Re: Building Permit Application No. 20-070 – Add/Alt: Construct New Accessory Structure, First Floor Deck and Retaining Wall to Existing Dwelling at 86 Bayview Ave., Northport, N.Y. S: 6 B: 3 L: 52
Residence District C

INC. VILLAGE OF NORTHPORT
BOARD OF ZONING APPEALS
APPLICATION

PROJECT: CUSICK-CORBELLINI
86 BAYVIEW AVE.
NORTHPORT, NY. 11768

SCHEMATIC PLOT PLAN

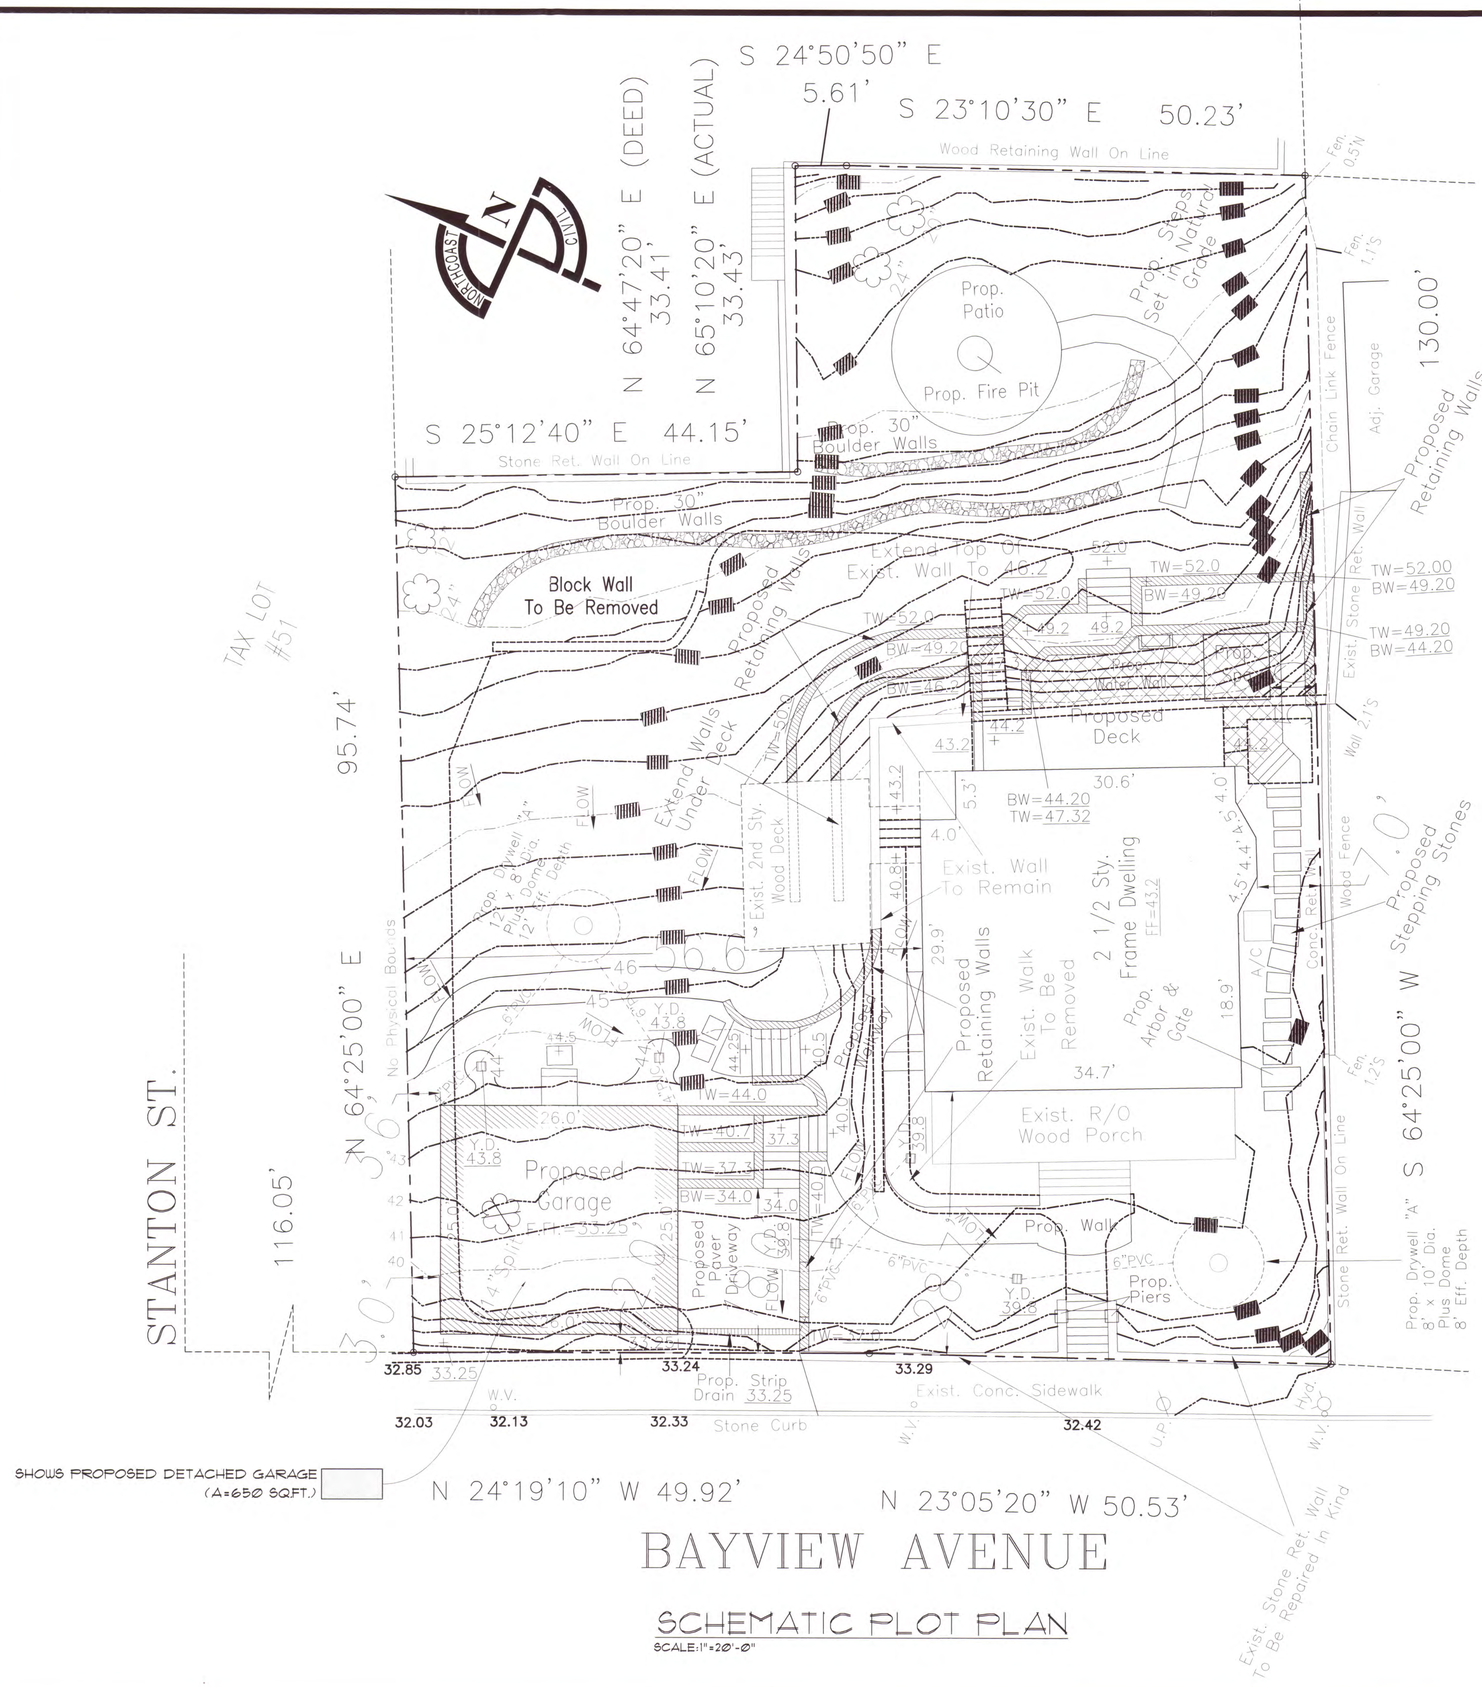
Your application to construct additions and alterations to the existing residence at the above-referenced address is hereby denied. Review of the schematic plot plan by Louise A. Agnes Architect P.C. & Associate dated 6/9/20 based upon a survey by JM Land Surveying dated 10/7/16 indicates that this is a non-conforming lot specific to Lot Area, Front Yard and Side Yard. Examination of schematic plot plan by Louise A. Agnes Architect P.C. & Associate dated 6/9/20, indicates that the construction would create a Lot Coverage of 26% and a footprint of 3,010 sf.

The proposed construction is, therefore, in violation of the Code of the Village of Northport, Chapter 306, "Zoning," Section 306-22K (1)(C), Section 306-22H (3), Section 306-23B (1), Section 306-23C (3).

The existing lot has several existing conditions for which variances are required:
Section 306-22 K (1)(C): Maximum Lot Coverage: 26% where 20% is required
Section 306-22 H (3): Side Yard: 2.5 feet where 18 feet is required
Section 306-23 B (1)(A): Detached Accessory Buildings: Minimum setback from street lines
Section 306-23 C (3): Detached Accessory Buildings: Side Yard: 3 feet where 7 feet is required
